DESIGN PH	DRAWN BY AJS	DART AEROSPACE USA, INC. PORT HADLOCK, WA
CHECKED <i>[Signature]</i>	APPROVED <i>[Signature]</i>	DRAWING NO. DSI 9364
DATE 08.08.06	TITLE BUSHING INSTALLATION	REV. C SHEET 1 OF 1
A	07.01.16	SCALE NTS
B	07.03.20	ADD TOLERANCE TO 1/2" HOLE
C	08.08.06	ADDED CHG 005 & SUBS TO EFFECTIVITY

DART SERVICE INSTRUCTION

TO AMEND IIN-D412-742 REV. D AND ICA-D412-742 REV. 3

DETAIL A: D3591-1 BUSHING INSTALLATION LOCATION

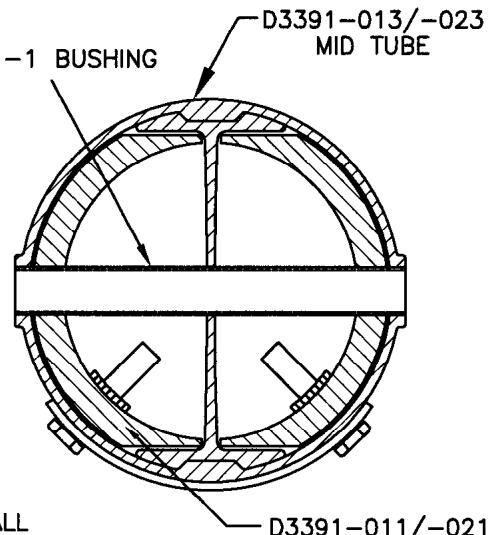
TO PREVENT THE D3391-011/-021 FWD TUBE FROM MOVING WITH RESPECT TO THE D3391-013/-023 MID TUBE, CUSTOMERS RECEIVING D412-742-011/-013 SKIDTUBES AT CHG 002 OR CHG 005 AND SUBSEQUENTS HAVE A D3591-1 BUSHING INSTALLED AT THE FWD SADDLE HOLES AS SHOWN IN DETAIL A (2 PLACES).

CUSTOMERS WITH D412-742-011/-013 SKIDTUBES AT CHG 001, CHG 003 AND CHG 004 CAN PROCURE THE DSI 9364-011 KIT AND INSTALL THE D3591-1 BUSHINGS AS FOLLOWS:

- 1) REMOVE SKIDTUBE/SADDLES FROM AIRCRAFT USING SECTION 32.7 OF ICA-D412-742 AS A GUIDELINE.
- 2) TRANSFER DRILL 1/2" HOLES ($\varnothing 0.500 \pm 0.006$) INTO THE FWD SADDLE HOLES AT THE LOCATIONS SHOWN (2 PLACES) THRU THE D3391-013/-023 MID TUBE AND D3391-011/-021 FWD TUBE. DO NOT OPEN UP HOLES IN D2571/D2572 FWD SADDLES.
- 3) REMOVE FWD TUBE FROM MID TUBE, DEBURR DRILLED HOLES, TOUCH UP HOLES WITH MIL-P-85582 OR MIL-P-23377 PRIMER
- 4) RE-INSTALL D3391-011/-021 FWD TUBE INTO D3391-013/-023 MID TUBE USING SECTION 32.7 OF ICA-D412-742 AS A GUIDELINE EXCEPT INSTALL D3591-1 BUSHINGS AS SHOWN IN DETAIL A USING LPS LABORATORIES LPS-3 CORROSION INHIBITOR PRIOR TO INSTALLING THE D2571/D2572 SADDLES.

ENSURE BOLT IS FASTENED
PRIOR TO TRANSFER DRILLING
(REF)
